### **ITEM FOR ENVIRONMENTAL COMMISSION AGENDA**

**NAME & NUMBER OF PROJECT:** Bridle Ridge at Wildhorse Ranch  
C8-2023-0259

**REQUEST:** Variance request is as follows:  
Request to vary from:  
1) 25-8-341 to allow cut over four (4) feet, to 15 feet.  
2) 25-8-342 to allow fill over four (4) feet, to 15 feet.

**STAFF RECOMMENDATION:** Staff recommends this variance, having determined the findings of fact to have been met.

CUT FILL EXHIBIT

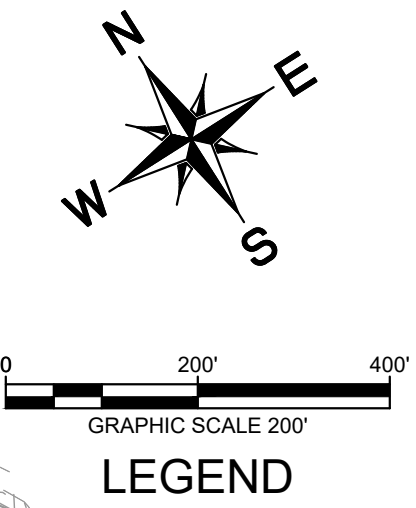
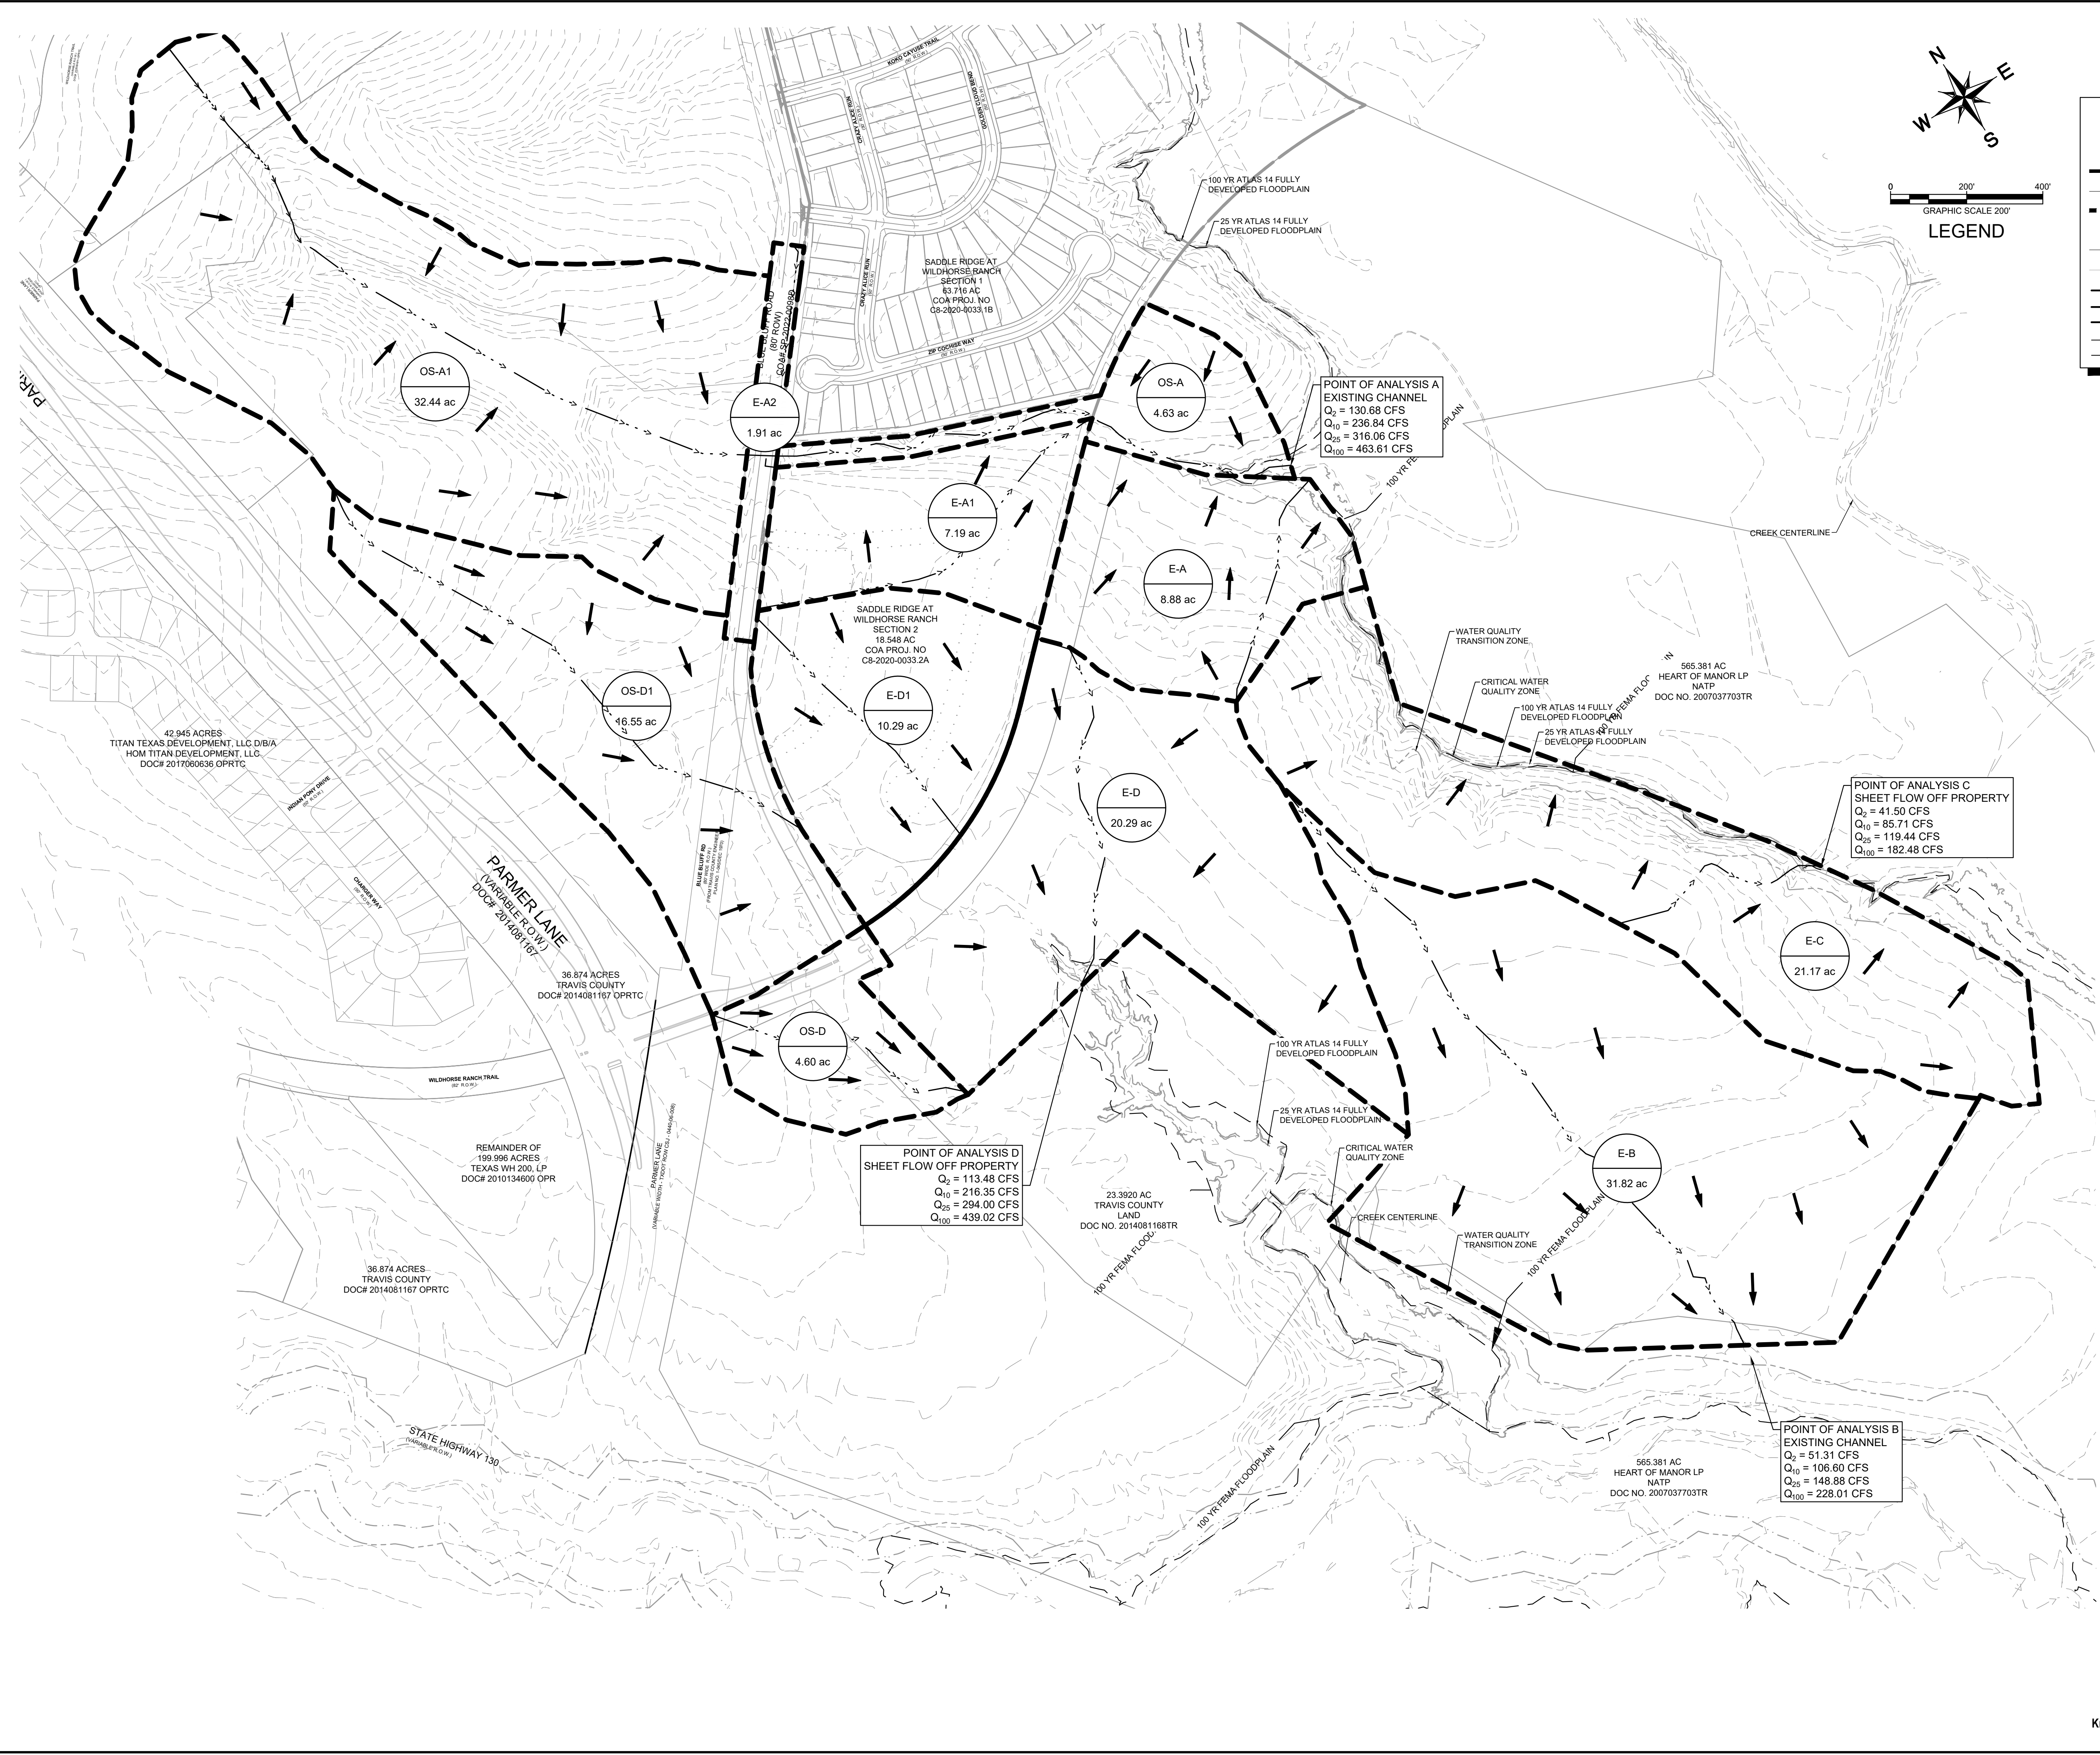
1. Slope stabilization for areas of existing erosion adjacent to the lots, will be provided with grouted rip-rap or approved equivalent method.
2. Slope stabilization in area of cut over 8 feet will be provided by terracing, 25 feet at 15% grade and 20 feet at 5% grade, and revegetation with native grasses and forbs (per Standard Specifications Manual 609S.5).
3. Fill over 8 feet will be contained with engineered walls.
4. The water quality ponds will be biofiltration ponds.

Clearly indicate in what way the proposed project does not comply with current Code (include maps and exhibits)	Per the attached cut/fill exhibit, there are areas that require cut/fills greater than 8'.
---	--

REAR LOT GRADING TO BE TERRACED  
FOR SLOPE STABILIZATION  
- 15% FOR 25 FEET  
- 5% FOR 20 FEET

ROUTED RIP-RAP OR APPROVED EQUAL  
SLOPE STABILIZATION METHOD TO BE  
DESIGNED WITH SUBDIVISION CONSTRUCTION PLANS
